UNITED STATES PATENT AND TRADEMARK OFFICE

APPLICATION NO.	FILING DATE	FIRST NAMED INVENTOR	ATTORNEY DOCKET NO.	CONFIRMATION NO.
10/786,933	02/25/2004	Toshinobu Homan	4041J-000844	5063

Office Action Summary

DETAILED ACTION

Figure 1 Iwanami et al.

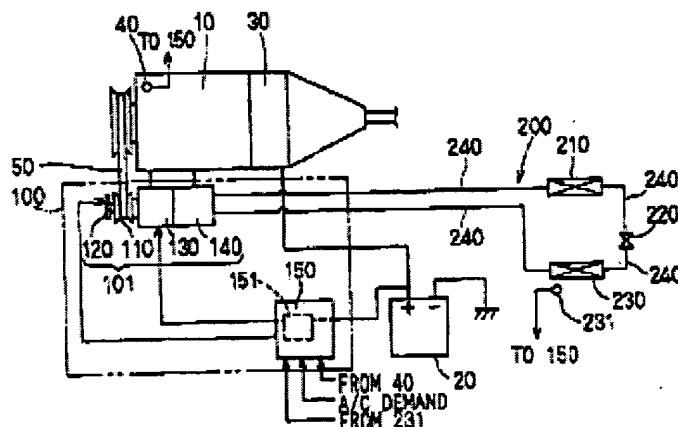
Regarding claim 1, Iwanami et al. teaches compressor control system capable of being used for an air conditioner of a vehicle (Figure 1).

Iwanami further teaches a hybrid vehicle with a driving electric motor 30 (column 6 lines 10-20), a main battery 20 capable of supplying electric power to the motor (column 7 lines 10-20). In addition, Iwanami discloses a compressor 140, in a refrigerant cycle 200 of the vehicle air conditioning system, with a motor 130 (column 2

lines 34-53). The motor includes a control means 150, which controls its rotation speed (column 4 lines 10-17).

Iwanami et al. fails to teach a driving electronic control unit with a function for controlling a drive power switching of the vehicle. Tamegai (US 6287081) discloses a control apparatus for a hybrid compressor with a control unit 22 capable of switching the vehicle between the driving engine and driving motor mode (column 2 lines 6-16). It would have been obvious to one of ordinary skill in the art at the time of the invention to modify Iwanami with Tamegai in order to provide the ability to switch from the driving engine to the driving motor modes of operation, thus taking advantage of the economic benefit of the driving engine and the efficiency benefits of the driving motor.

Figure 2 Takahashi et al.

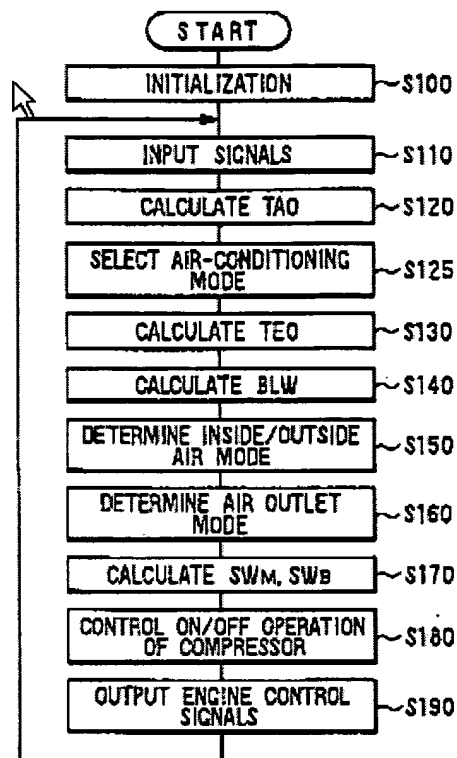
Regarding claims 2 and 3, Iwanami in view of Tamegai fails to teach an air conditioning unit and a driving electronic control unit in communication with one another. Takahashi discloses a vehicle air conditioning system with an air-conditioning electronic control unit (A/C ECU) 5, which controls operation of the air conditioner based on an air conditioning signal input (column 13 lines 37-66). Takahashi further teaches the air conditioning electronic control unit can communicate with a driving electronic control unit of the system (column 14 lines 1-5). Takahashi further discloses the air conditioning ECU 5 and vehicle ECU 38 can communicate with one another through a local area network made up of microcomputers each of which has a CPU, ROM, RAM and additional peripheral circuits (column 14 lines 30-46). It would have been obvious to one of ordinary skill in the art at the time of the invention to modify Iwanami in view of Tamegai with Takahashi in order to enable the air conditioning system (A/C ECU) to function separately from the system that drives the vehicle (ECU). This prevents problems that occur with vehicles that have a single (ECU) to operate both the air conditioner and the vehicle. An example of this is when a vehicle engine drives the compressor of the air conditioning system and there is an increase in temperature of the passenger compartment of the vehicle due to a vehicle stoppage.

In regard to claim 4, Takahashi teaches an air-conditioning electronic control unit 5 capable of calculating a target air temperature and blowing amount of conditioned air blown into a vehicle passenger compartment (column 14 lines 58-66 and column 16 lines 10-20 and Figure 2).
